UNITED STATES PATENT AND TRADEMARK OFFICE

APPLICATION NO.	FILING DATE	FIRST NAMED INVENTOR	ATTORNEY DOCKET NO.	CONFIRMATION NO.
10/785,196	02/25/2004	Joseph J. Randazzo	3691-654	3373

Office Action Summary

DETAILED ACTION

Fig. 3

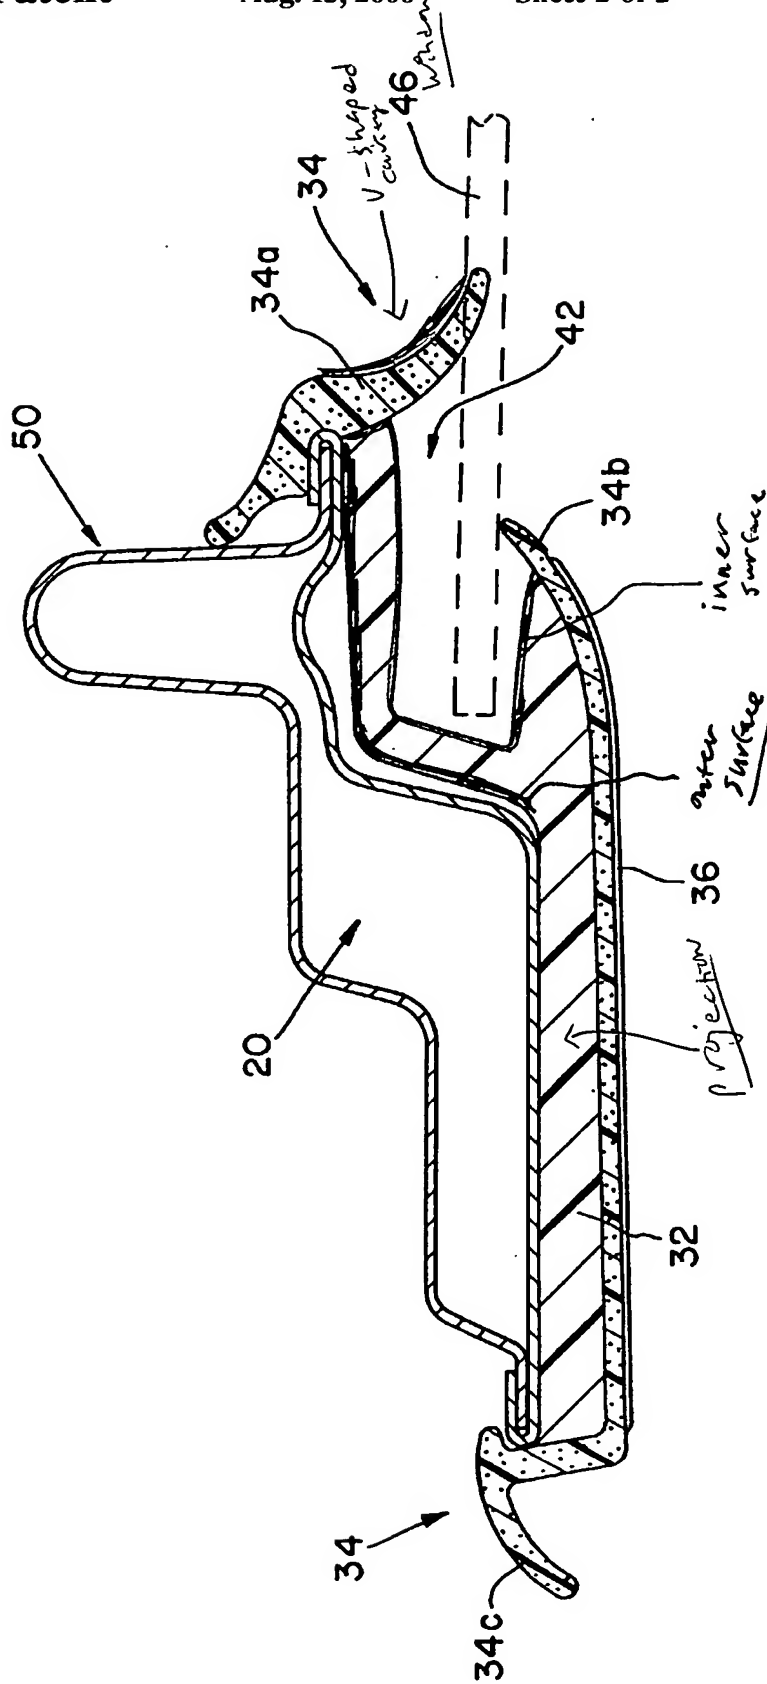
For claim 9, Kelly (6,103,168) discloses applique for use at a pillar area of a vehicle (Figure 1), the applique comprising: a polymer inclusive substrate 32, the polymer inclusive substrate including an interior surface to be closest to a vehicle window and an exterior surface to be further from the window than is the interior surface (Figure 3); a polymer inclusive flexible thermoplastic elastomer portion 34 including at least one flexible lip or leg for engaging a surface or edge of the vehicle window 46, wherein said substrate and said thermoplastic elastomer portion are “bonded” at least on part of said interior surface of the substrate which is to be closest to the vehicle window (Column 4, lines 31-38); wherein said thermoplastic elastomer portion and said substrate are of different materials having different hardness values which are selected so that the thermoplastic elastomer portion and the substrate are molded or bonded to one another without a separate adhesive layer therebetween, and the thermoplastic elastomer portion is more flexible than the substrate; and wherein said substrate includes a projection (Figure 3) extending from the exterior surface of the substrate 32, said projection being approximately perpendicular to a base portion of the substrate, and wherein said projection extending from the substrate does not contact said thermoplastic elastomer portion that includes the lip or leg that is for engaging the surface or edge of the vehicle window (see marked-up copy of Figure 3, hereto attached).

With regard to claim 12, the thermoplastic elastomer portion 34 at least partially defines a cavity, wherein one side of the cavity is defined by a first portion of the thermoplastic elastomer portion and another side of said cavity is defined by a portion of the thermoplastic elastomer portion that is to engage the window (see marked-up copy of Figure 3, hereto attached).
